Appl. No. 10/707,152
Amd. Dated October 14, 2005
Reply to Office Action Dated June 8, 2005

Amendments to the Drawings:

FIG. 16A

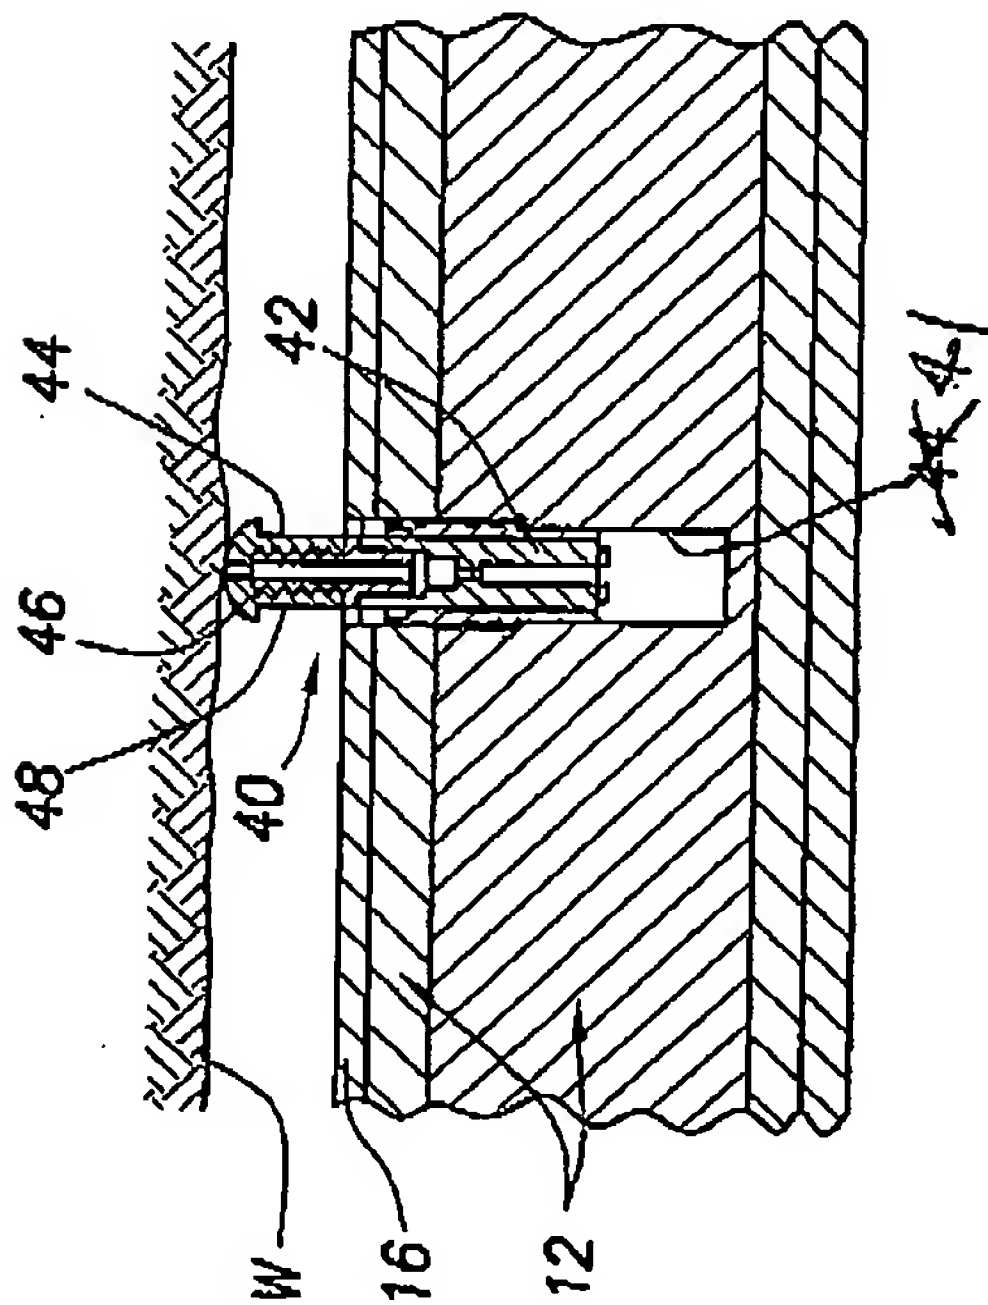
The attached sheet of drawings includes changes to Figs. P1 and 16A. These sheets, which includes Figs. P1, 16A, 16B, 17A and 17B, replaces the original sheets including Fig. P1, 16A, 16B, 17A and 17B. In Fig. P1, reference number 131 has been removed. In Fig. 16A, duplicate reference number 44 has been changed to reference number 41.

Applicant has detected certain errors in the specification and drawings and has submitted amendments herein to correct these errors. In the drawings, Applicant has removed reference number 131 of Fig. P1, and replaced duplicate reference number 44 with 41 in Fig. 16A to conform to Fig. 16B.
